## Planning Commission Issues Report

**Subject:** Change of Zoning Issues Report

**Petition:** P.Z. 11-2016 Wild Horse Bluffs (17439 and 17455 Wild Horse Creek Road)

**RE: Wild Horse Bluffs – P.Z. 11-2016 Response Letter**

ISSUE DATE  
 8/9/2016  
 SCALE  
 AS SHOWN  
 Job Number  
 14014  
 Sheet Number  
 2

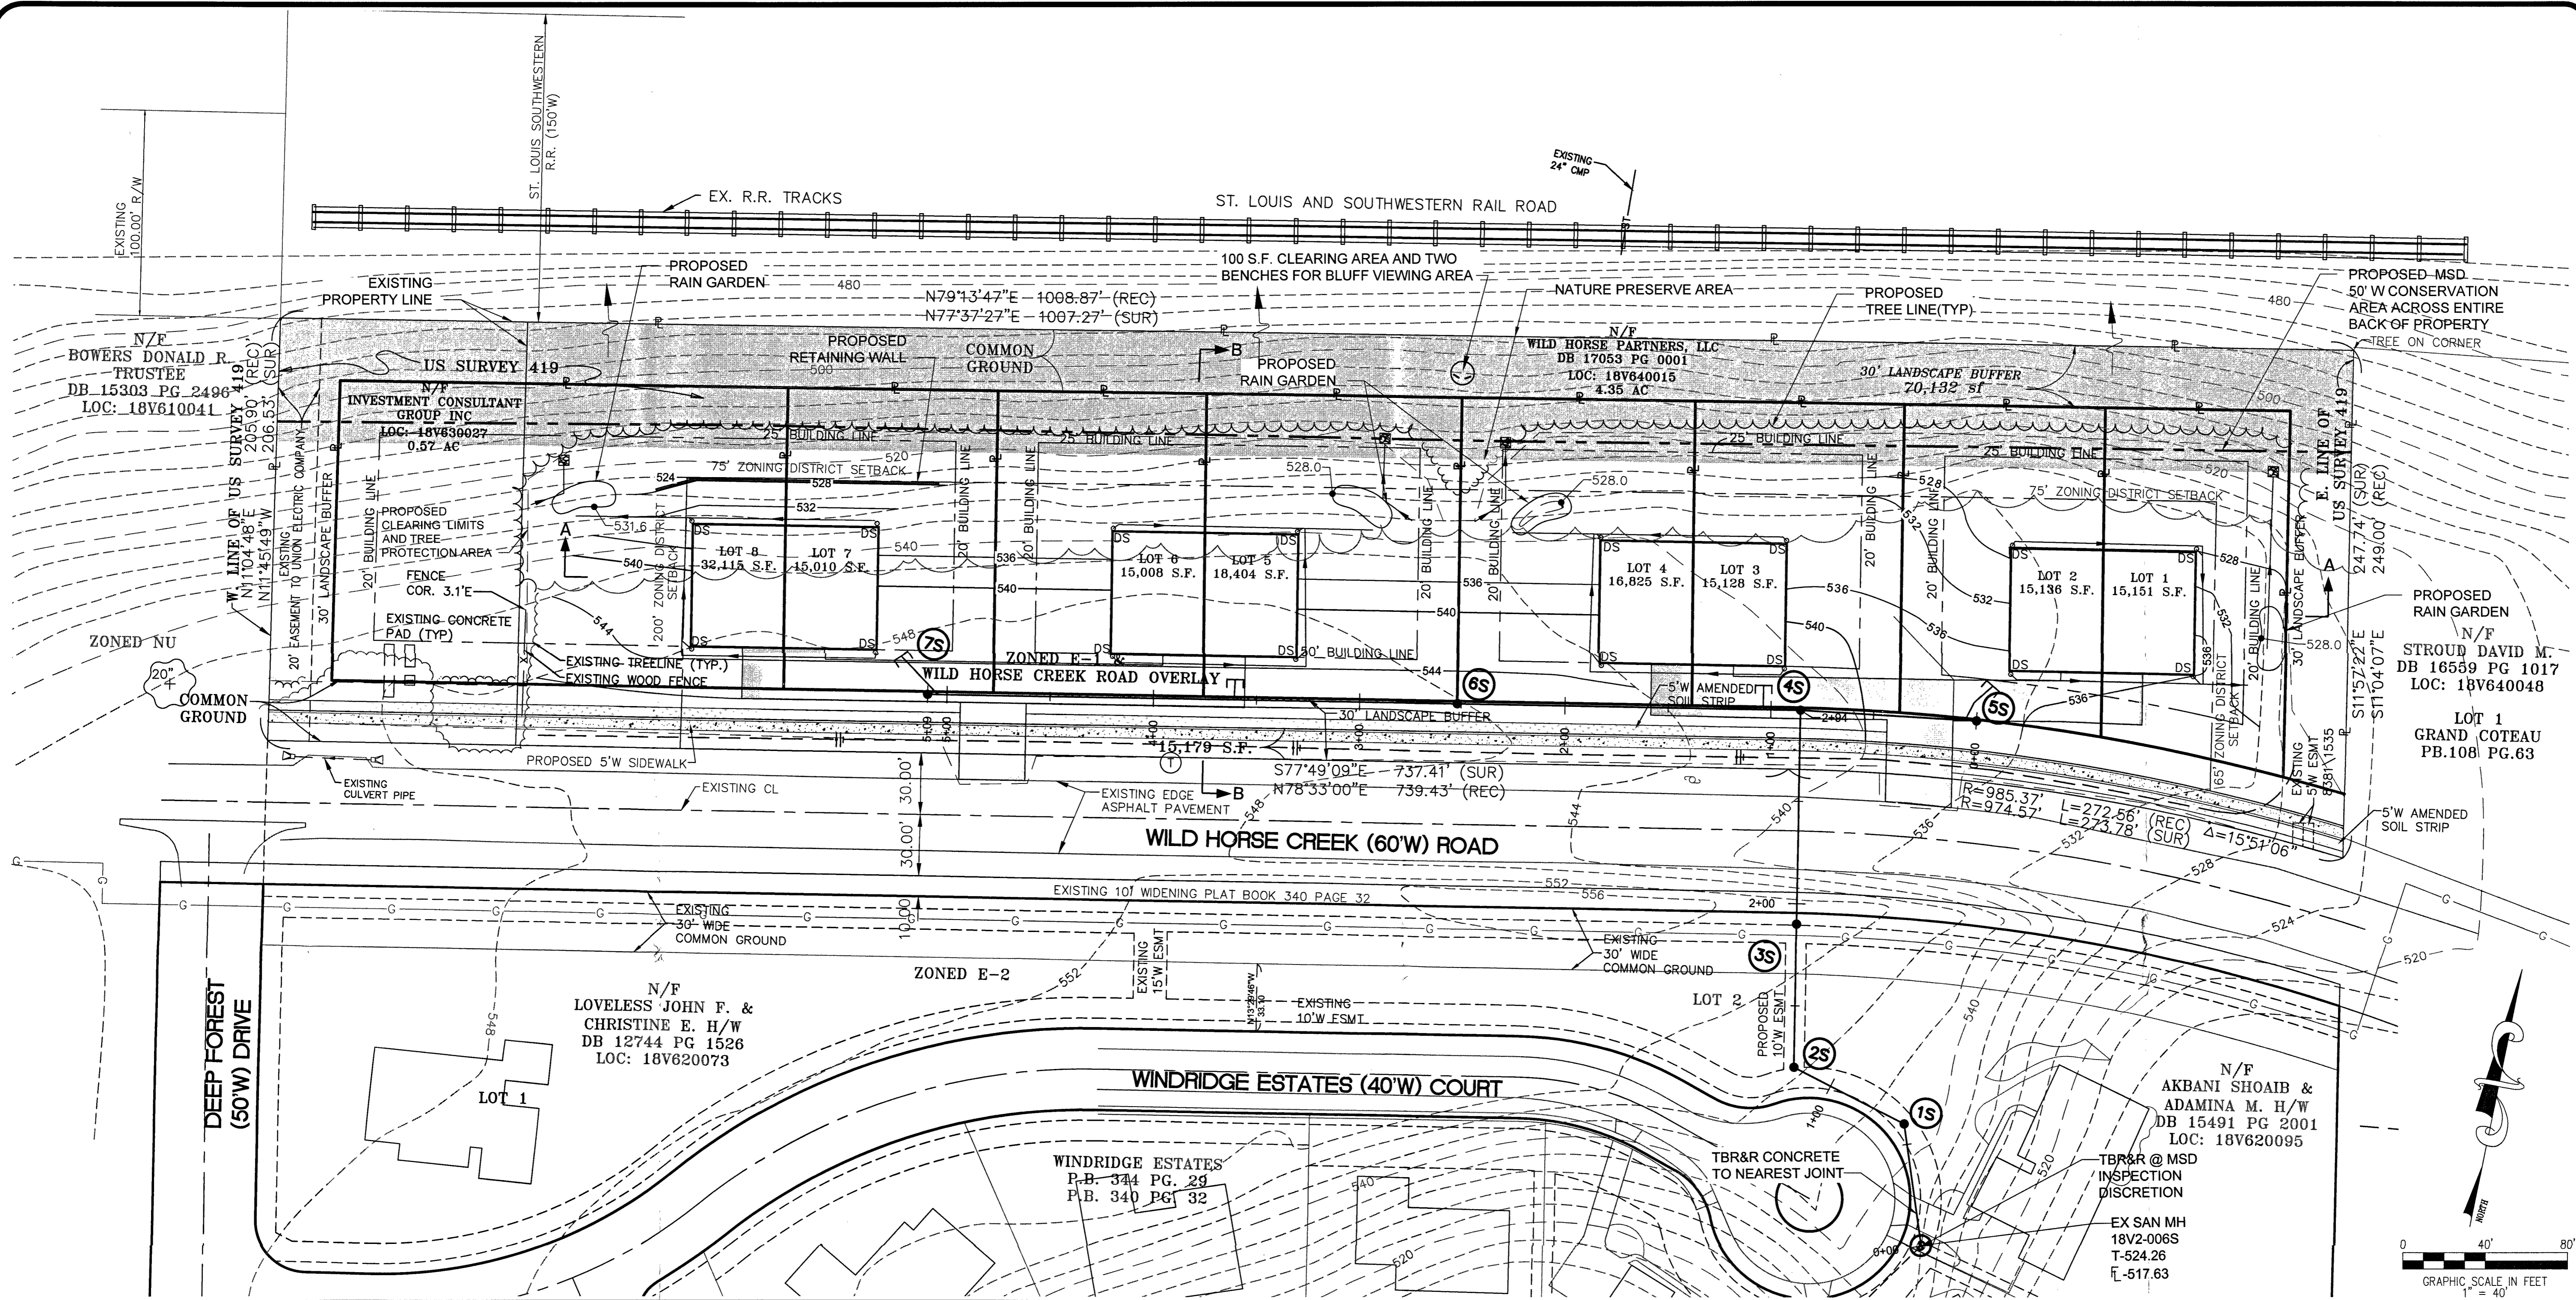
3. The Preliminary Plan does not provide or delineate community amenities, as required by the Wild Horse Creek Overlay District: "Community amenities, such as a community center, nature preserve areas, park, lake, recreation areas, and other similar uses and amenities, are required for all residential development and shall be shown on any preliminary plan and/or site development plan."

1. As you are requesting a modification to the side yard setback on the shared property line of the attached units, the preliminary plan should include a note identifying the modification request that will be made to the City Council. Please note that this modification request requires a separate, super majority [two-thirds (2/3)] vote by the City Council for approval.

*The plan has been revised to show a nature preserve area on the north portion of the property (the bluffs area), as well as a small seating area (including two benches) where*

*individuals could gather and view nature, which satisfies this requirement. The preserve area totals 1.4 acres out of the 4.89 acres total site.*

*This note has been added to the plan.*
